MONITORING YEAR 0 ANNUAL REPORT FINAL

HUNTSMAN MITIGATION SITE

DMS Project No. 100123

Subject: Huntsman Draft MYO Report Review
Yadkin River Basin – CU# 03040102
Wilkes County
DMS Project ID No. 100123
Contract # 7891

Figure 3.0 – 3.2 Current Condition Plan View

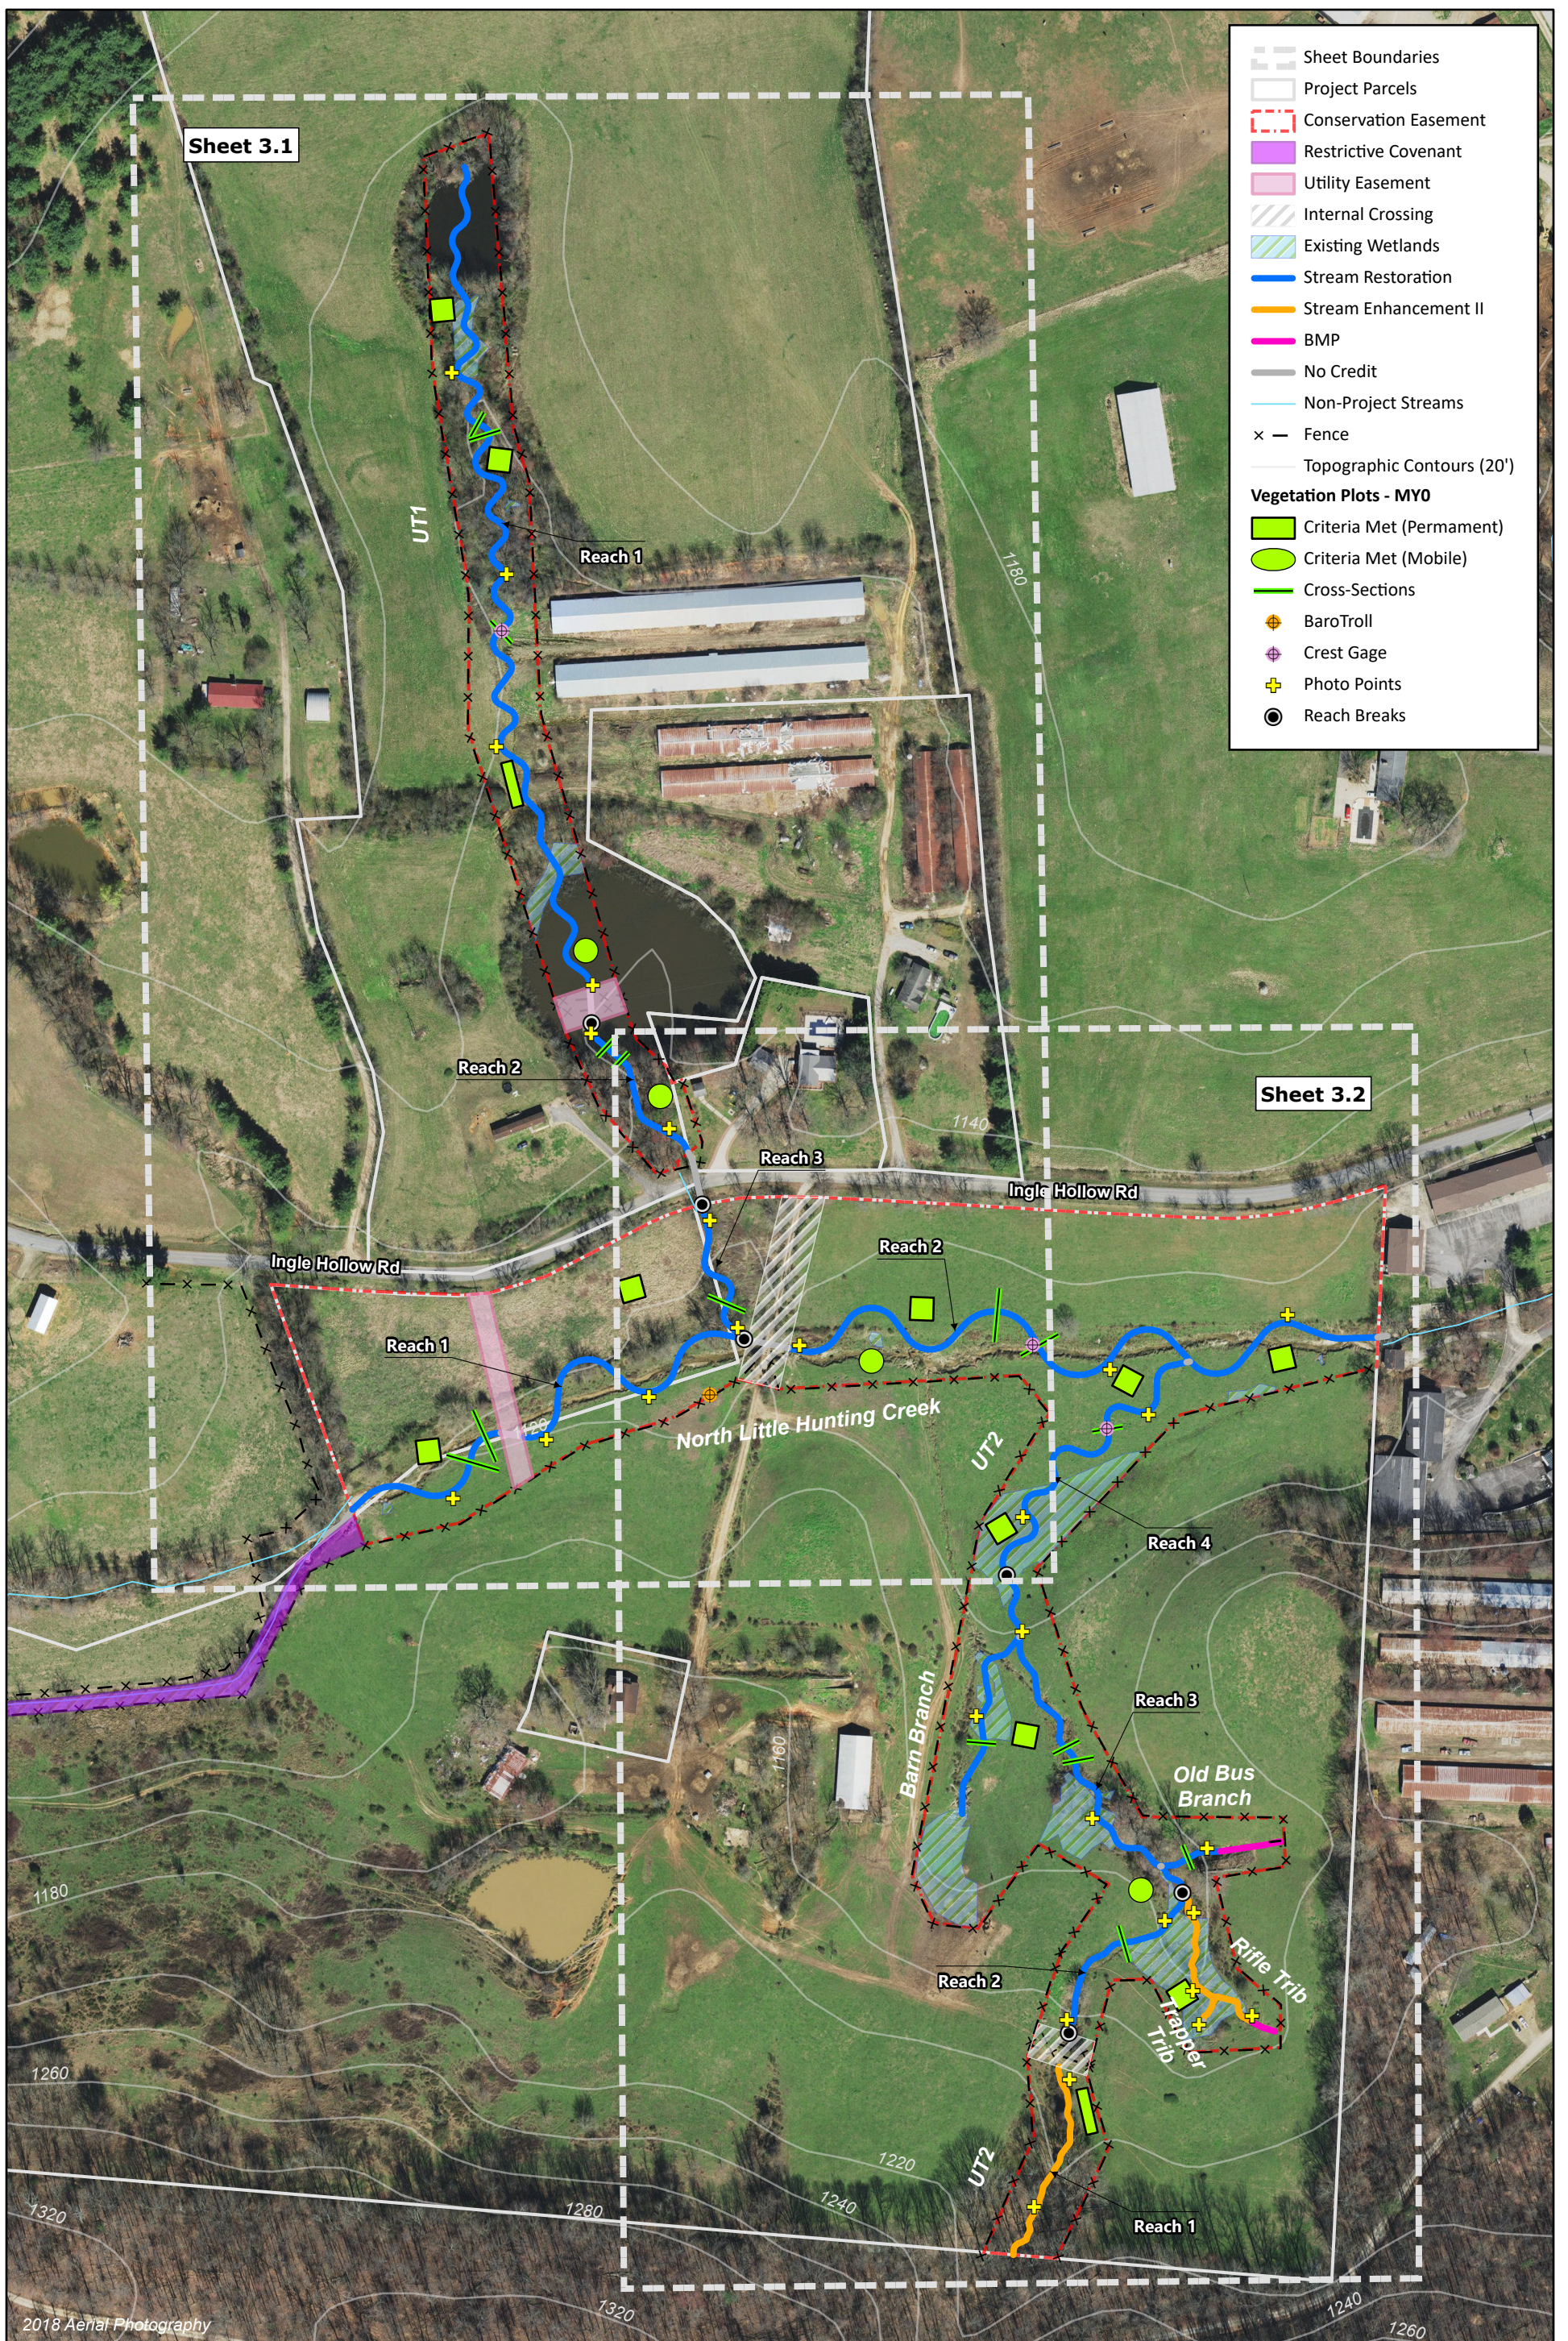
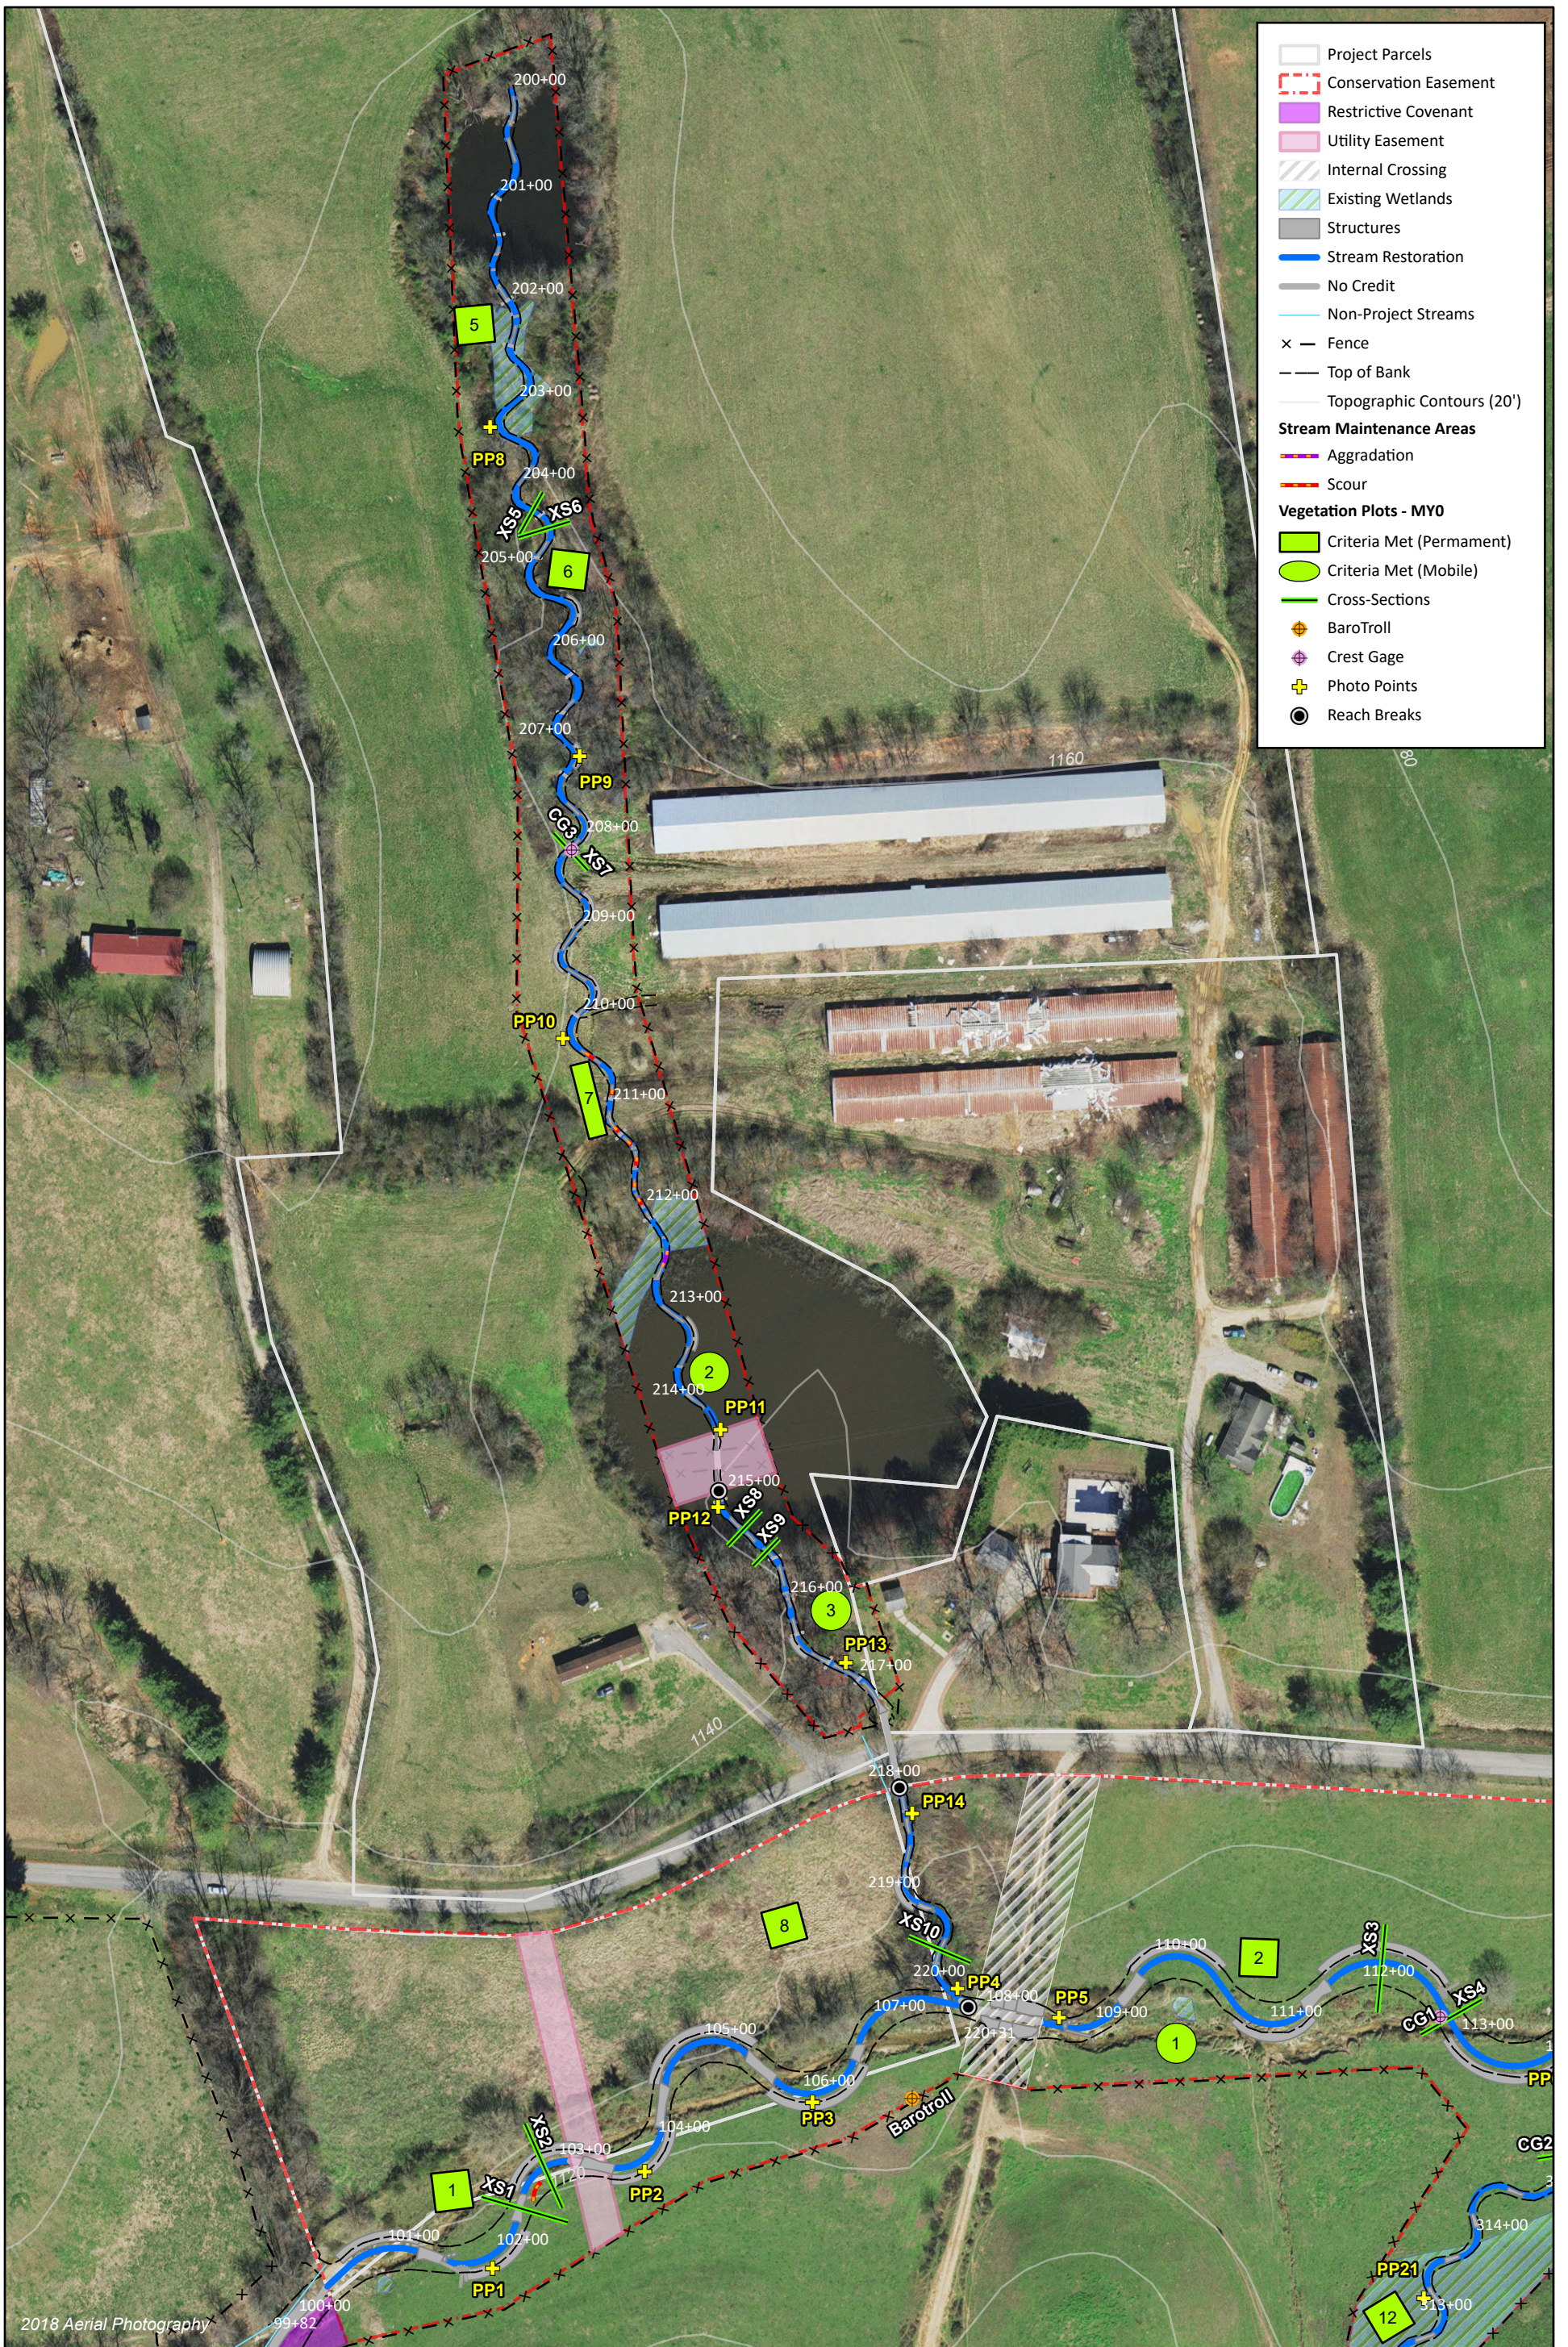
- 3.4 Stream Areas of Concern: Thank you for providing photos of the Stream Areas of Concern in Appendix A. Please add these locations to the CCPV. Are there any maintenance activities planned to correct these issues at this time?

- CCPV: Recommend changing the color/line type of the conservation easement so it is easily discernable from other line work.
- Photo Points for Trapper Trib and Rifle Trib do not seem to indicate a defined channel with bed and bank. These credits are potentially at risk if these tribs are unable to maintain stream features and become wetlands. Please provide an update in MY1 regarding the condition of these two tribs.

7. *CCPV: The Fence Line appears to be within the conservation easement in many areas on the CCPV. The asbuilt survey shows fence locations outside or on the conservation easement line. Please verify the fence was not installed inside the conservation easement and ensure correct line work is shown on CCPV.*

Wildlands Response: Stream areas of concern have been added to the CCPV maps for the final submittal. Depending on contractor availability, maintenance activities for areas of concern will be conducted in either late MY1 or early MY2. Wildlands will provide a status update in the MY1 report.

Wildlands Response: Wildlands verified that the fence line polygon was obtained from the as-built survey file. The issue was with symbol that was used to reflect the placement of the fence. The symbol has been corrected and updated, and it now correctly reflects the alignment of the fence.

Wildlands Response: The conservation easement color was changed to red so that it is easier to see in the CCPV figures.
